Item ID: DSI 9396-013 Accept \*N900040100\* Setup Start \*NS1\*  
 Revision ID: Stop \*NS2\*  
 Item Name: Aft Crosstube Support Change  
 Start Date: 16/03/2012 Start Qty: 2.00 \*2\* Cust Item ID:  
 Required Date: 30/03/2012 Req'd Qty: 2.00 \*2\* Customer:  
 Reference:

# DART SERVICE INSTRUCTION

TO AMEND INSTALLATION INSTRUCTIONS IIN-D205-594 Rev. C (AND EARLIER) AND  
INSTRUCTIONS FOR CONTINUED AIRWORTHINESS ICA-D205-594 Rev. 2 (AND EARLIER)  
REF. CANADIAN STC: SH03-6  
REF. FAA STC: SR01742NY

**FIGURE 1: INSTALLATION OF SUPPORT ON CROSSTUBE**

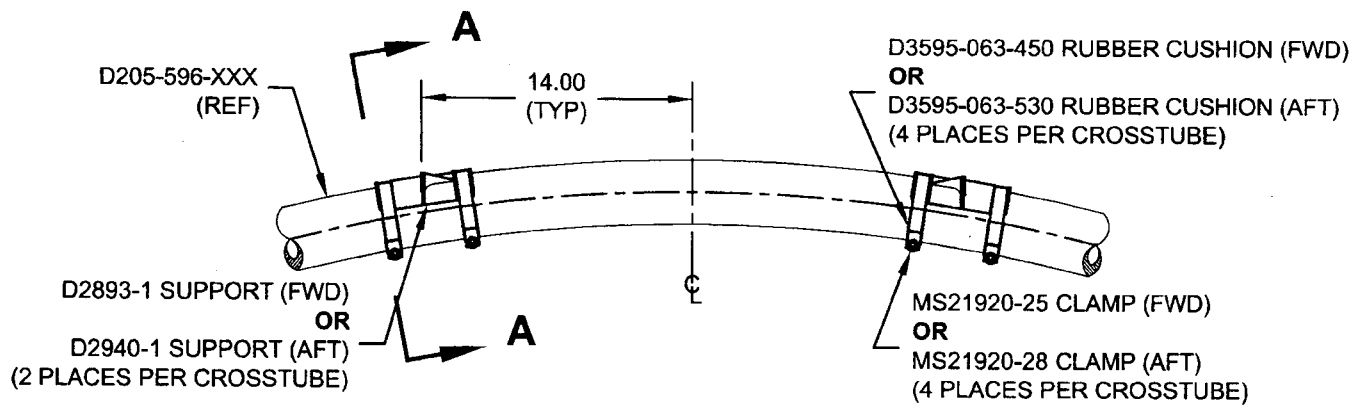
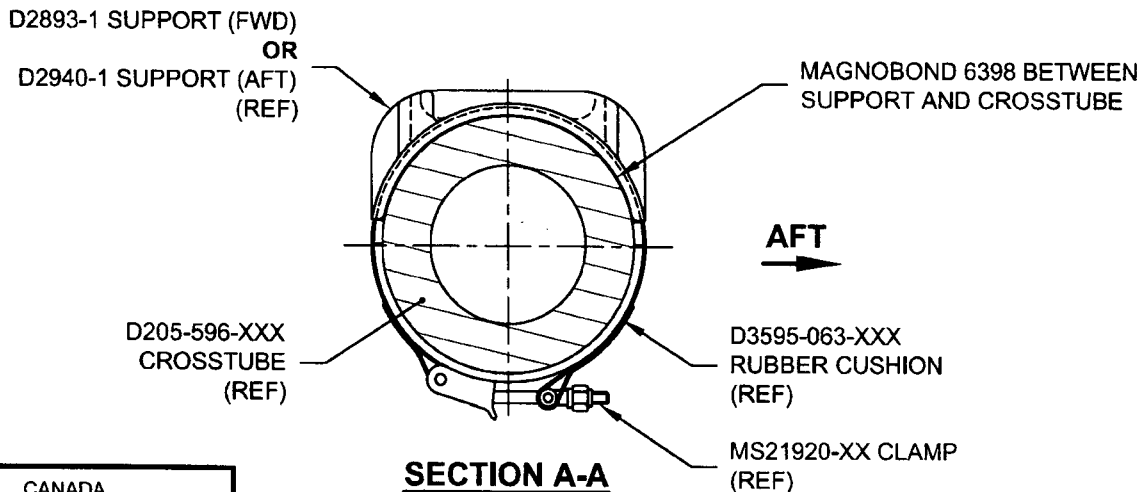
For D205-596-101/-103 Crosstubes (ref. 39" Landing Gear) or D205-596-105/-107 Crosstubes (ref. 31" Landing Gear) at CHG 002 or later, the D2856-600-851/-1009 Abrasion Strips have been removed, the MS21920-25 Clamp replaces the MS21920-24 Clamps, the D2893-1 and D2940-1 Supports have been bonded onto the crosstubes using Magnobond 6398 and D3595-063-450/-530 Rubber Cushions have been installed underneath the MS21920-25/-28 Clamps. Amend Parts List of IIN-D205-594 Section 5 and ICA-D205-594 Section 32.8 as follows:

To prevent the supports from shifting on D205-596-101/-103/-105/-107 Crosstubes at CHG 001, the D2893-1 or D2940-1 Supports should be removed and re-installed as follows:

- Apply a 0.03" to 0.06" thick layer of Magnobond 6398 underneath D2893-1 or D2940-1 Supports and re-install the Supports on the crosstube as shown in Figure 1. Install a D3595-063-450/-530 Rubber Cushion on each MS21920-25/-28 Clamp. Position and secure the D2893-1 or D2940-1 Supports on the crosstube using MS21920-25/-28 Clamps. Torque clamps to 80-100 in-lb. Let the D205-596-101/-103/-105/-107 Crosstube Assembly cure before re-installing the crosstube on the aircraft.

- Note:** It is acceptable to substitute the MS21920-25/-28 with longer or shorter clamps to accommodate varying diameters. Ensure there is a minimum of 1.5 threads in safety on the nut.
